**Pre-Preliminary Plan No. 720130010, Northwood Knolls**

**Completed: 5/2/13**

- Request for Planning Board advice for a proposed three-lot resubdivision;
- 503 Dennis Avenue, approximately 500 feet east of the intersection of Dennis Avenue and University Boulevard West;
- Zoned R-60; 33,354 square feet;
- Currently one single-family detached dwelling on one lot with multiple accessory structures, used as a residence and landscape company;
- 1996 *Four Corners Master Plan*;
- Applicant – Charles Clements
- Filing date: 10/10/2012

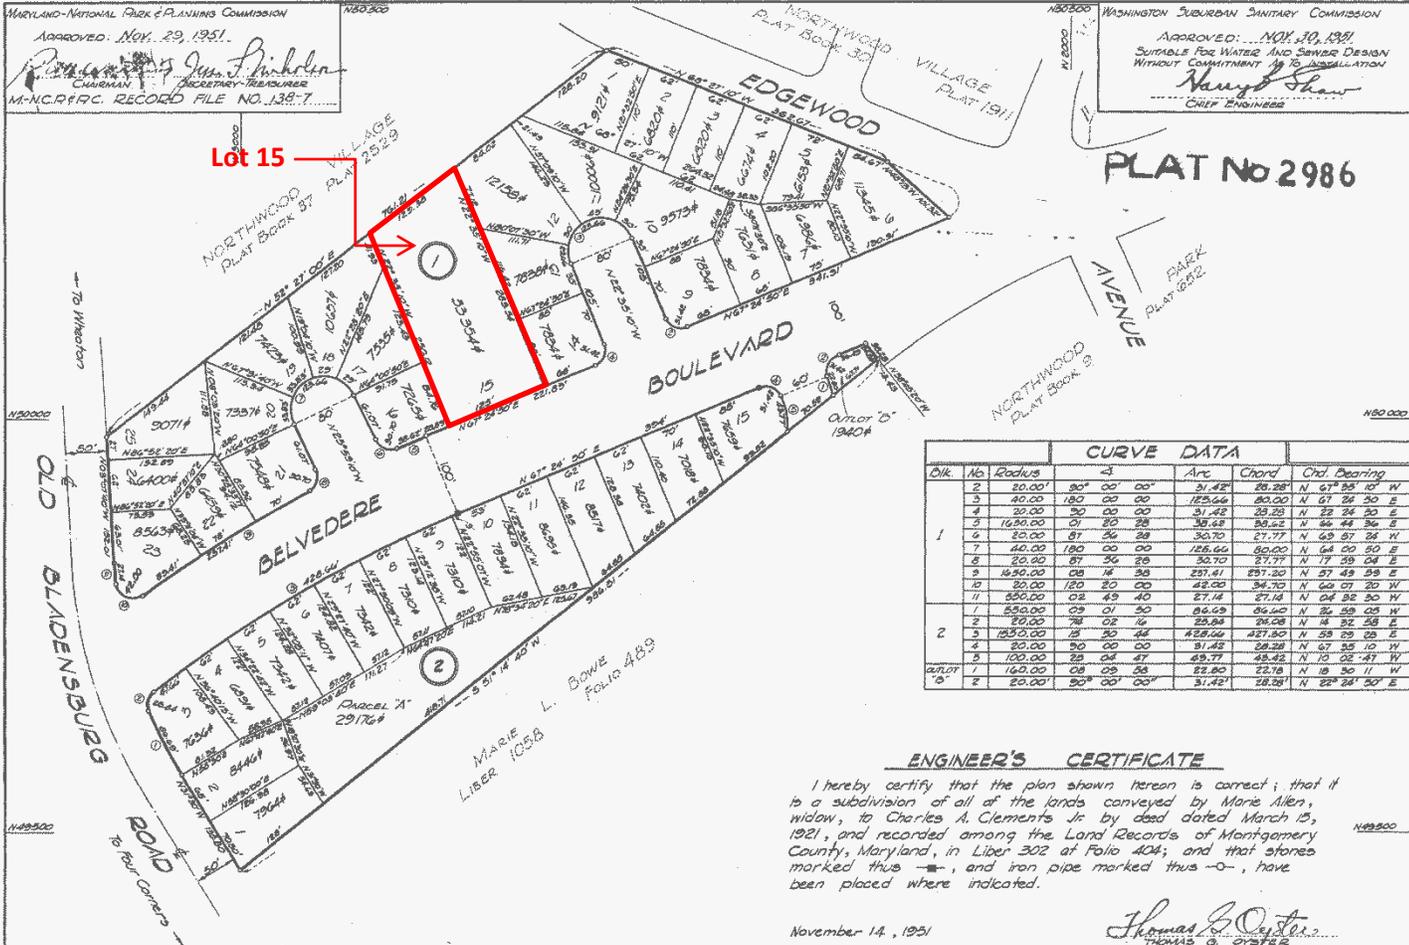
### Scenario 2 (Figure 4)

Scenario 2 meets the Lot Design criteria, under Section 50-29(a)(2) of the Subdivision Regulations in that the rear two lots will abut the public road via pipestems. However, this proposal needs a waiver from the resubdivision criteria under Section 50-29(b)(2) regarding frontage, and shape for the two flag lots. The proposed flag lots will have the smallest frontages and no flag lots currently exist in the defined neighborhood. The rear lot also needs a waiver for lot size and lot area since it will be the largest in the defined neighborhood.

Staff disagrees. The R-60 Zone does not guarantee three lots for the Property, which can be developed with two lots in accordance with the applicable Master Plan and R-60 Zone requirements without the need for a waiver and determination of exceptional circumstance, as demonstrated by Scenario 3 below.

Instead, staff would support a two-lot subdivision, which will be more consistent with the character of lots and pattern of the defined neighborhood, and will require no waivers from Subdivision Regulations. Therefore, staff does not object to the Applicant submitting a Preliminary Plan of resubdivision for two lots.

**Scenario 1, No Lot Frontage**

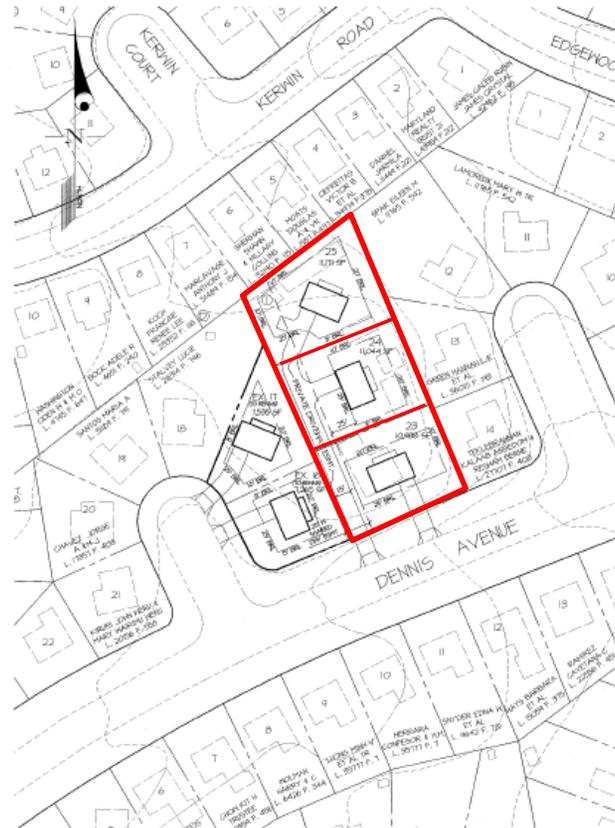
### Scenario 1 (Figure 3)

Scenario 1 does not meet the Lot Design criteria, as required under Section 50-29(a)(2) of the Subdivision Regulations (lots to abut on a public street), nor does it meet the resubdivision criteria with regards to consistency of the character of the proposed lots with existing lots in the defined neighborhood (under Section 50-29(b)(2)) since two of the three proposed lots would have no street frontage. Additionally, the lot fronting on Dennis Avenue would be traversed by two driveways, only one of which will serve the front lot.

There is no exceptional circumstance to support the proposed three-lot resubdivision with two of the lots accessing the street via a private driveway. Scenario 2 shows that the Property can be resubdivided into three lots without the need for a determination of exceptional circumstance to support a waiver for this requirement. The Subject Property was intentionally left larger and surrounded by smaller residential lots (see Attachment 1) and was created initially by the subdivision of land in 1950. Therefore, staff does not recommend further consideration of this alternative.
